Change of diameter with brake disc 54211

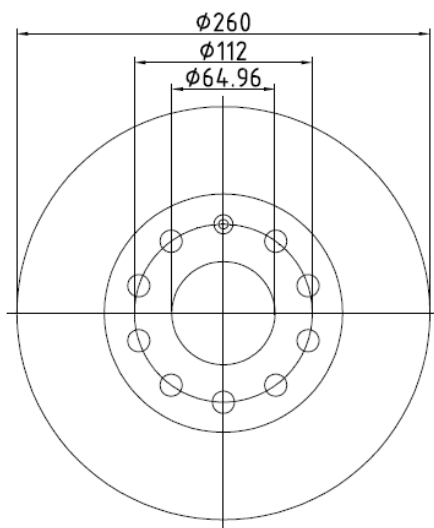
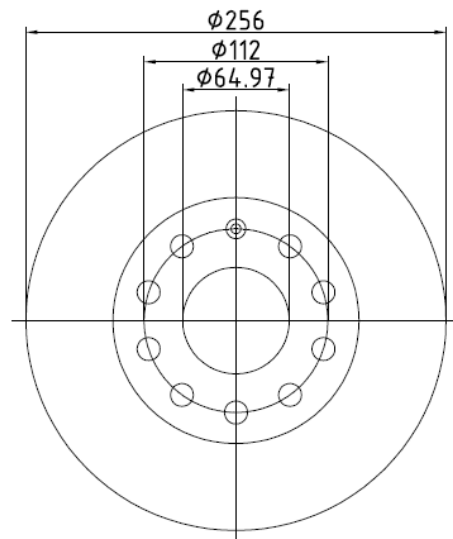
Due to diameter modifications of the car manufacturer (Volkswagen-Group), the diameter of our brake disc 54211 will be reduced from 260 mm to 256 mm.

Although the original spare part has got a new article number, we will introduce this new design as a running change into the market by keeping the existing reference number.

This change of the dimension avoids corrosion at the outer radius, which in the past frequently caused noises, and led to claims in technical inspections.
